**Paycor Stadium Southeast & Southwest VT Escalator Towers
Bid Package 2: Steel, Demo & Concrete
ITB#033-26
Addendum 3**

May 6, 2026

SECTOR 4 - LEVEL 400 & 500 DEMOLITION FLOOR PLAN

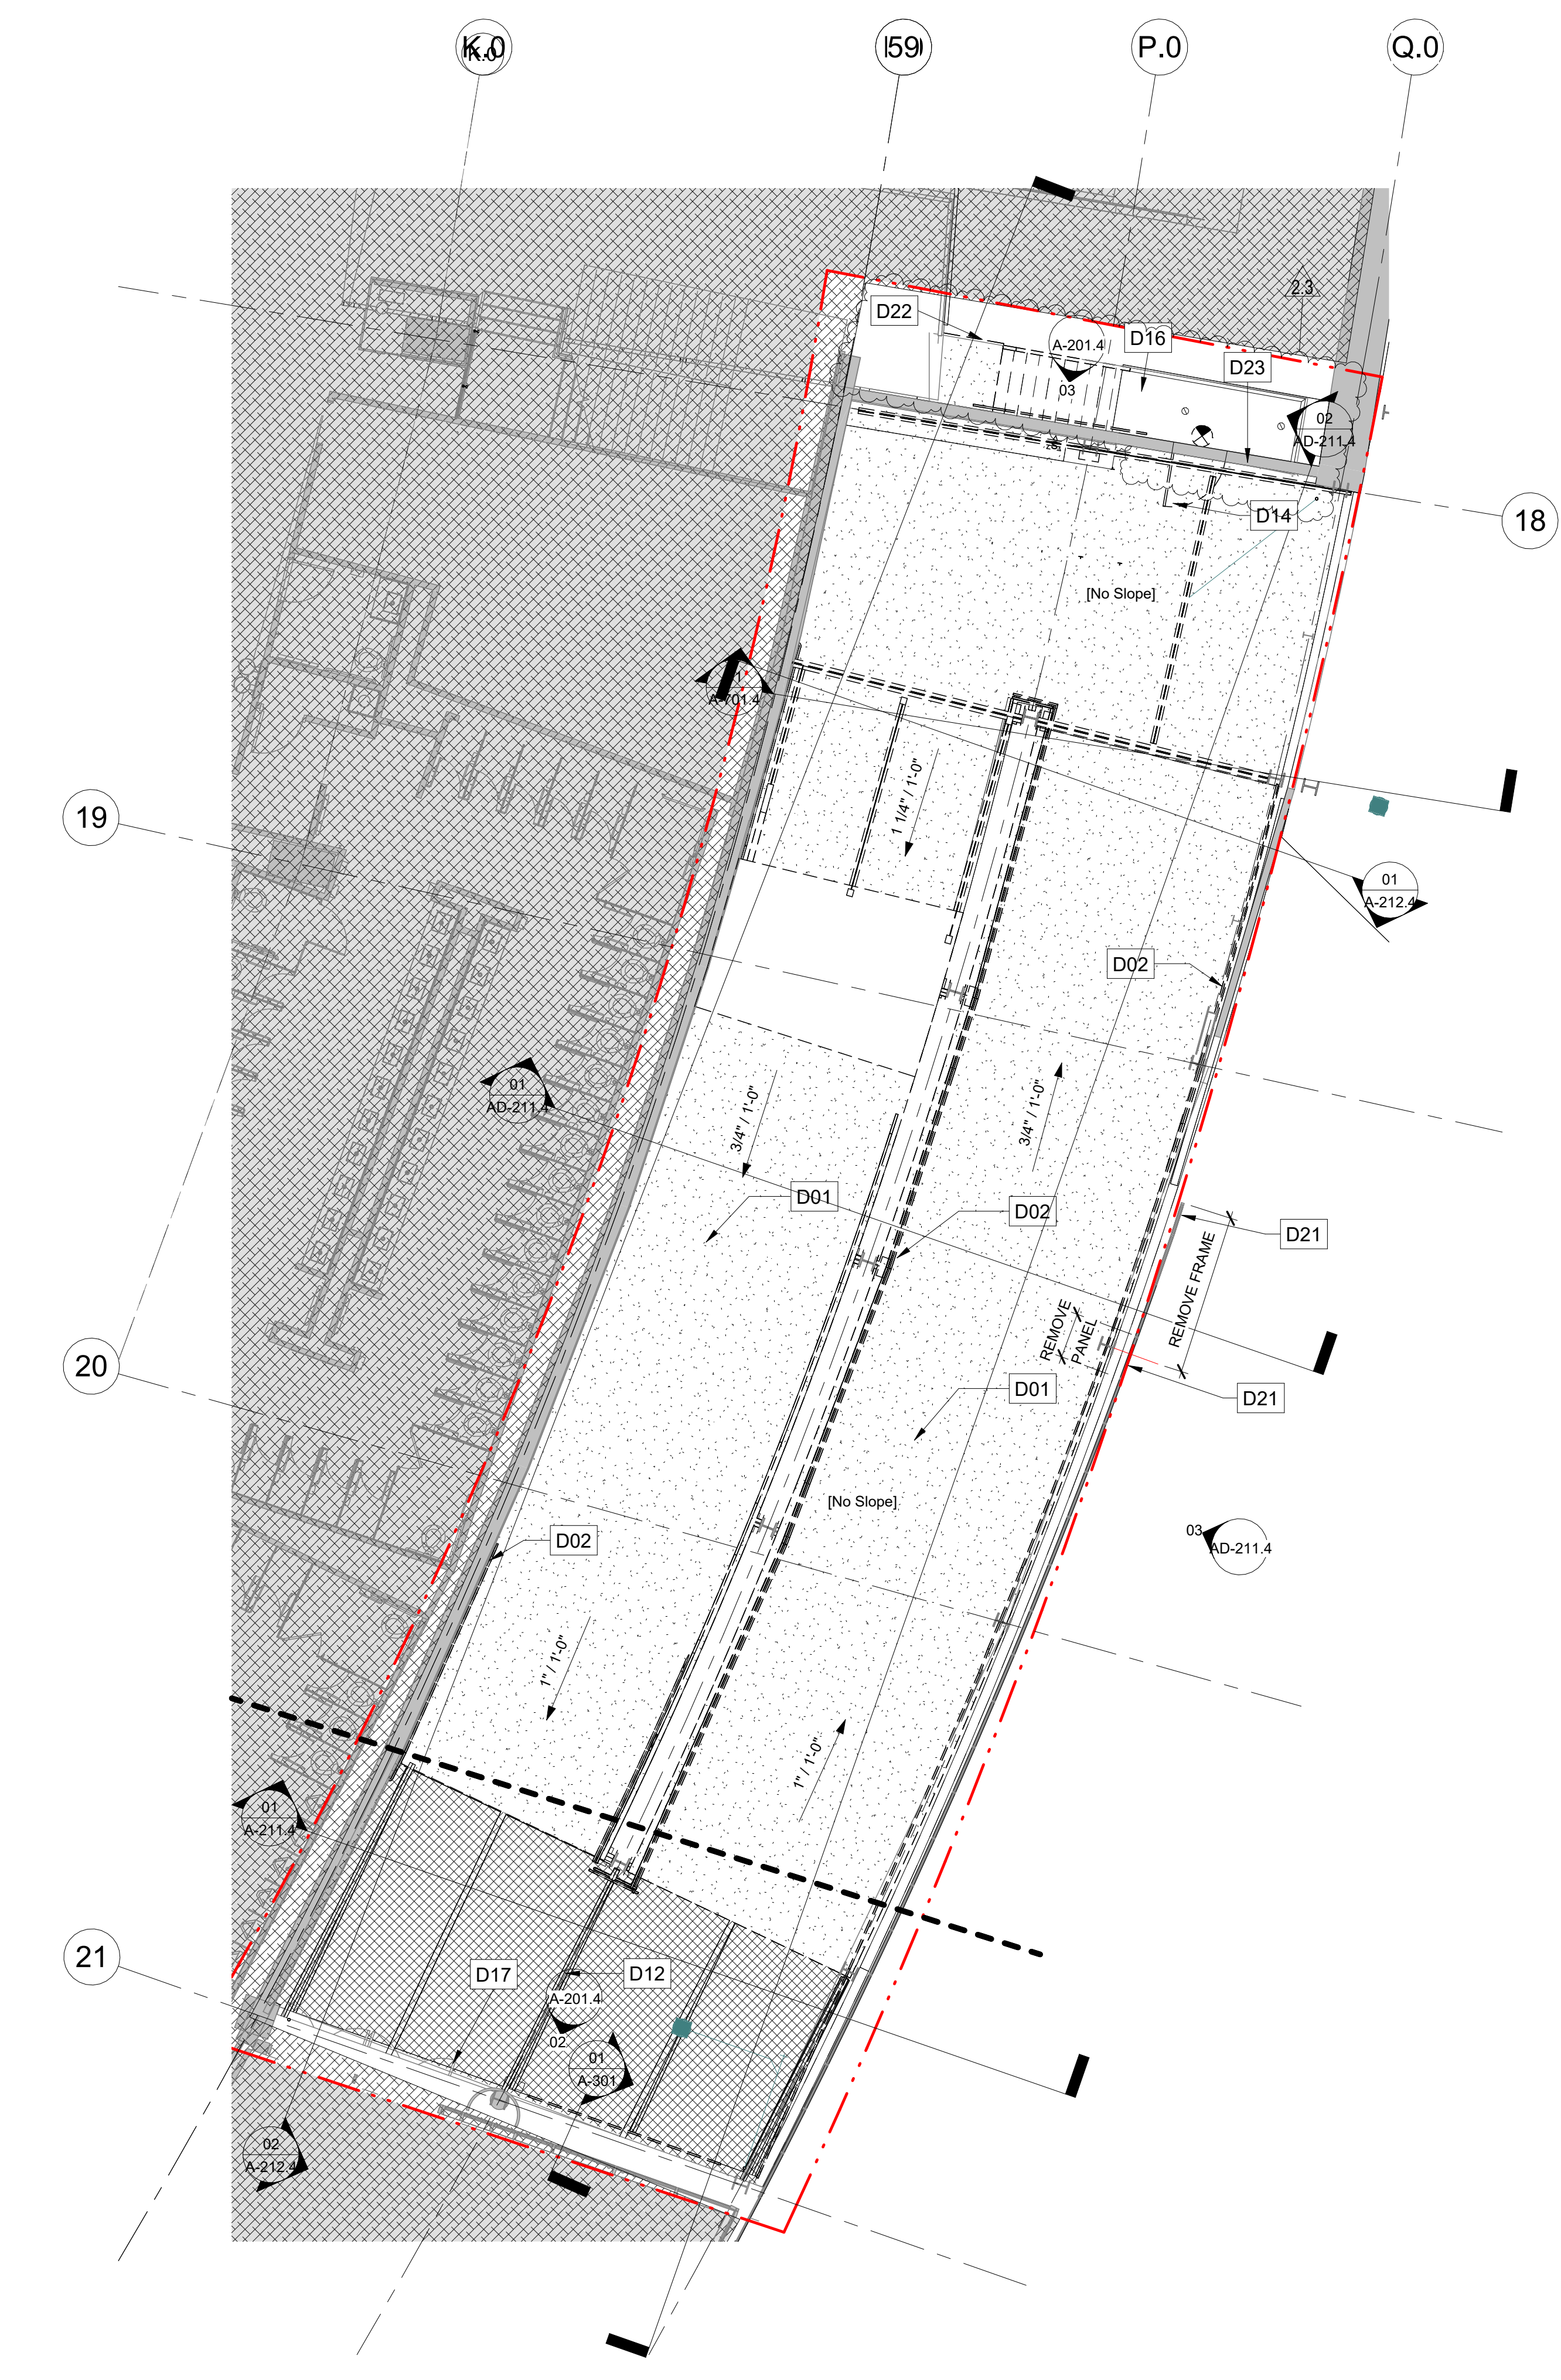
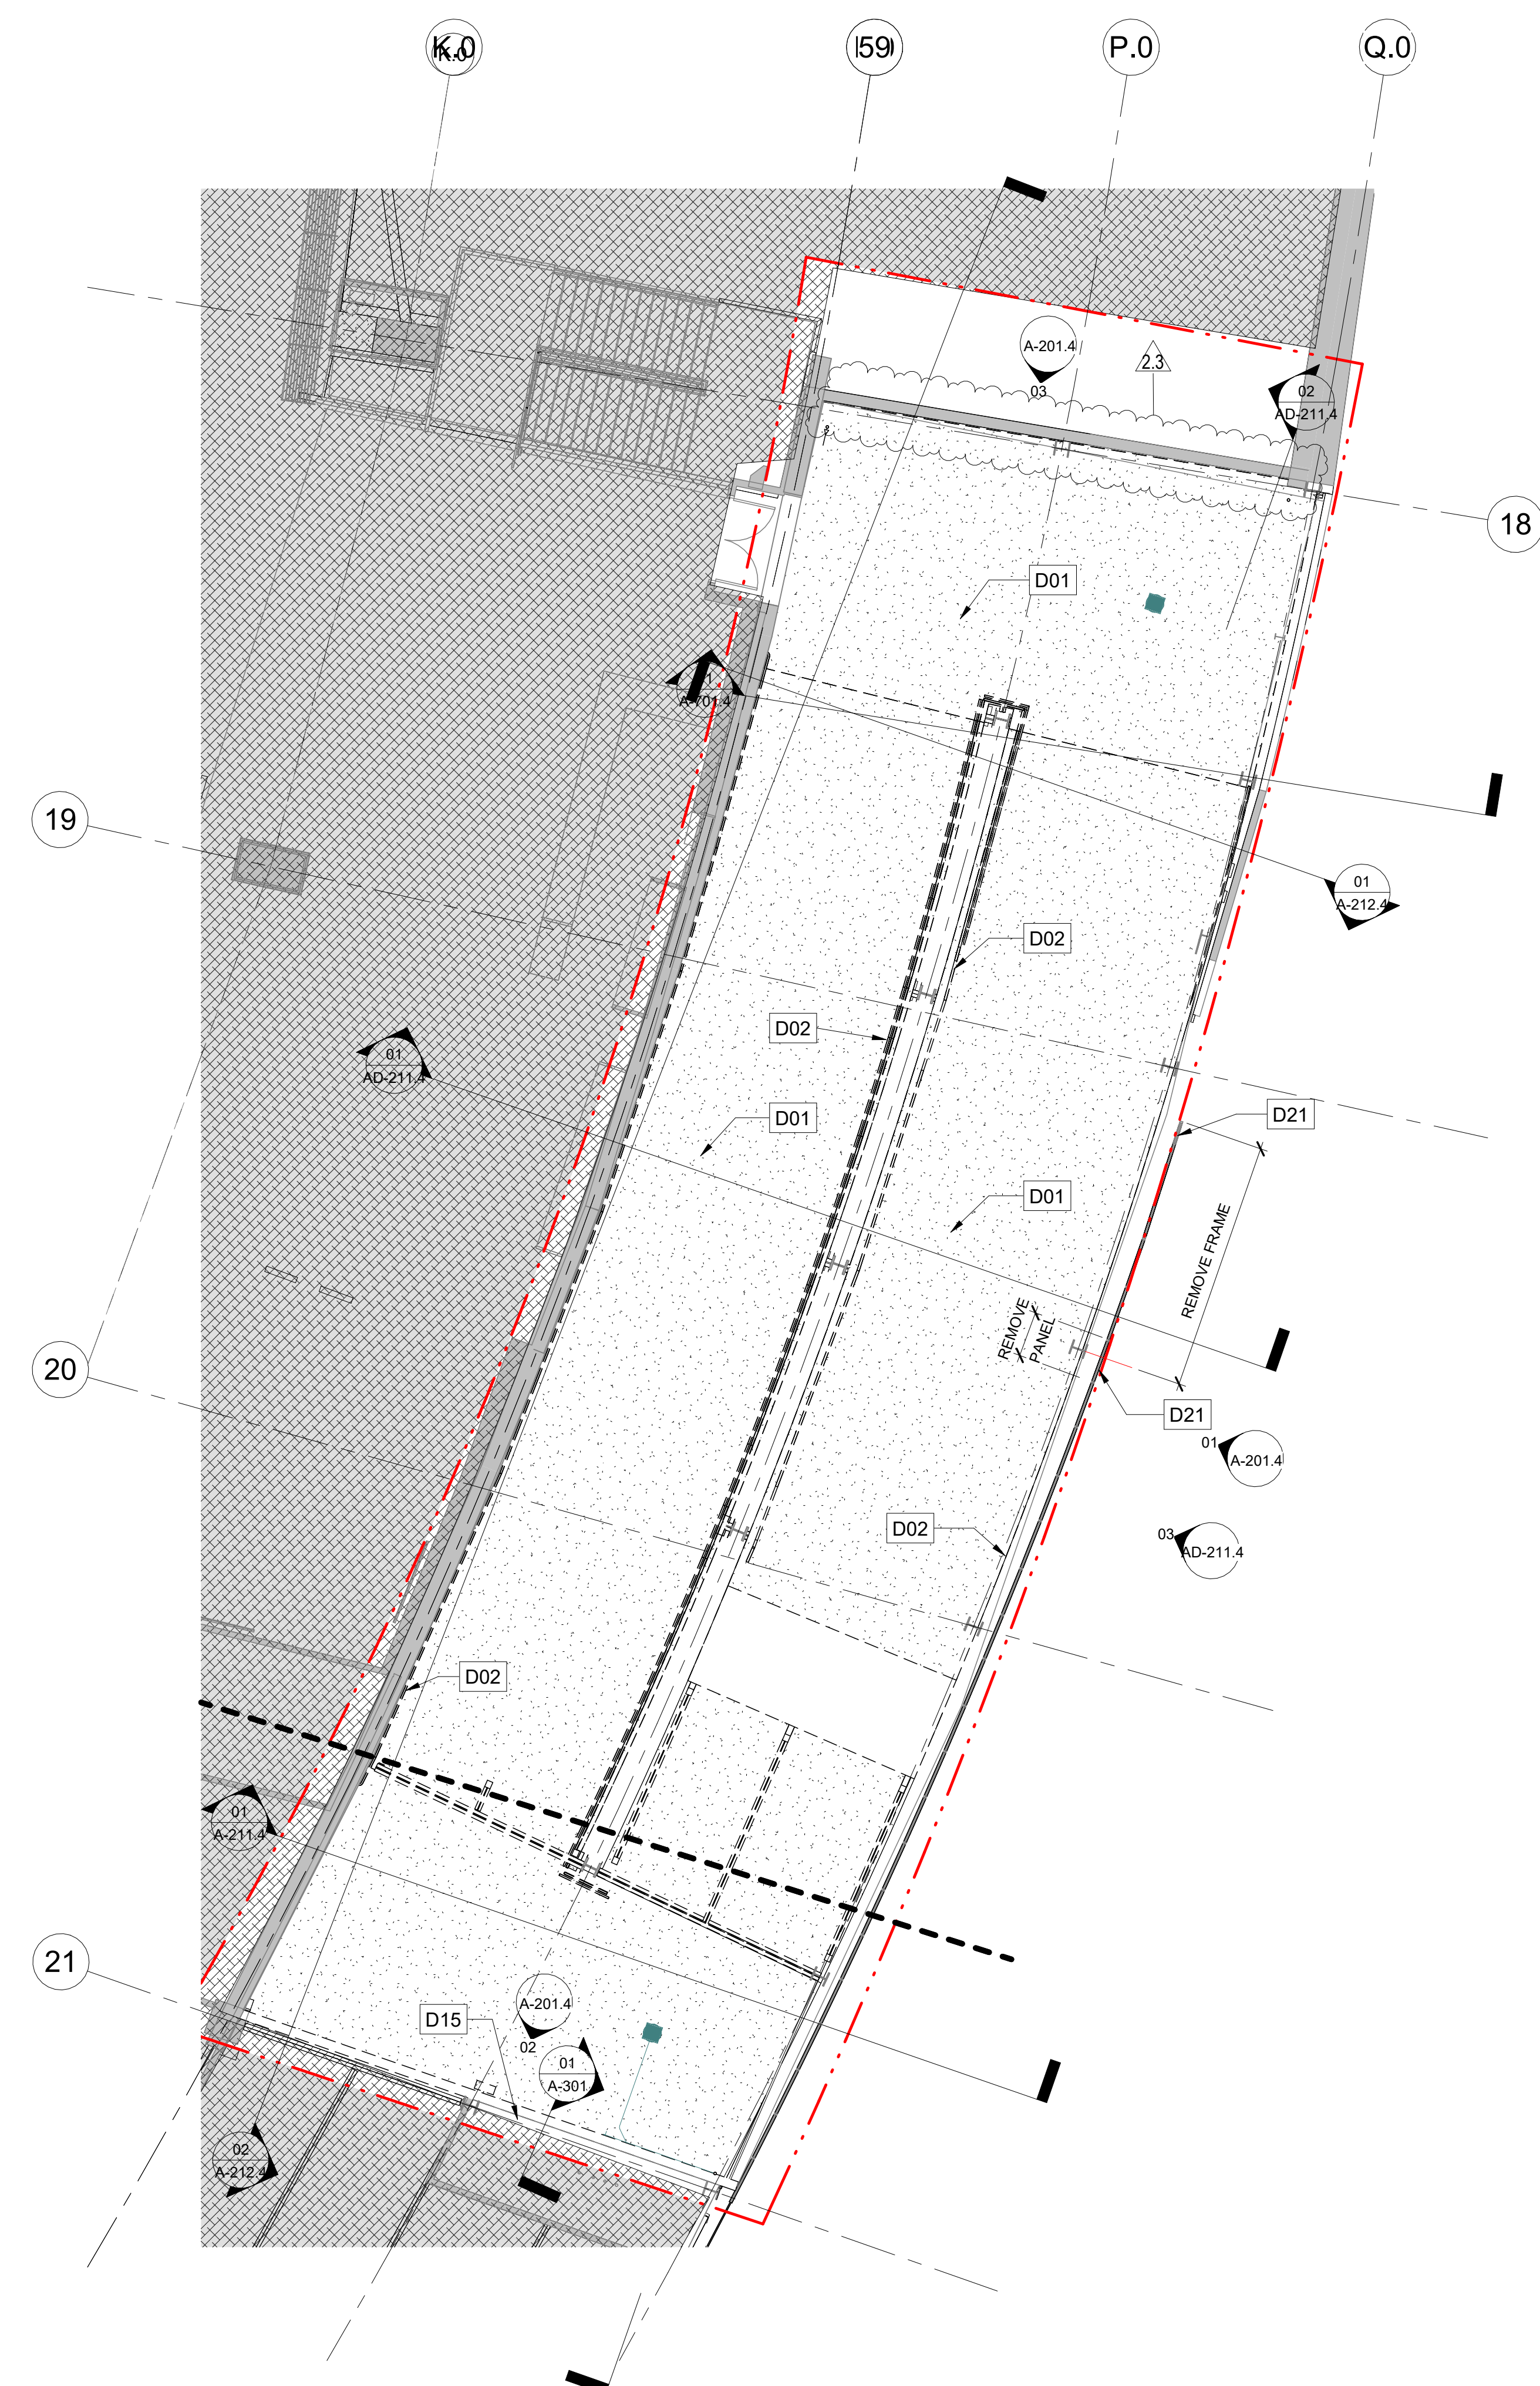
AD-101	New sheet with existing photos.
AD-103.4	Sector 4 – Level 400, 500 North wall to remain with limited demolition to remove existing Club stair.
AD-104.4	Sector 4 – Level 600 North wall to remain
AD-211.4	Sector 4 – Demolition Section & Elevation North wall to remain with limited demolition to remove existing Club stair.
S-103	Refer to sheet for clouded revisions
	Framing revisions
	S-104
	Refer to sheet for clouded revisions
	Framing revisions
S-105	Refer to sheet for clouded revisions
	Framing revisions
	Added section cuts
S-106	Refer to sheet for clouded revisions
	Framing revisions
S-108
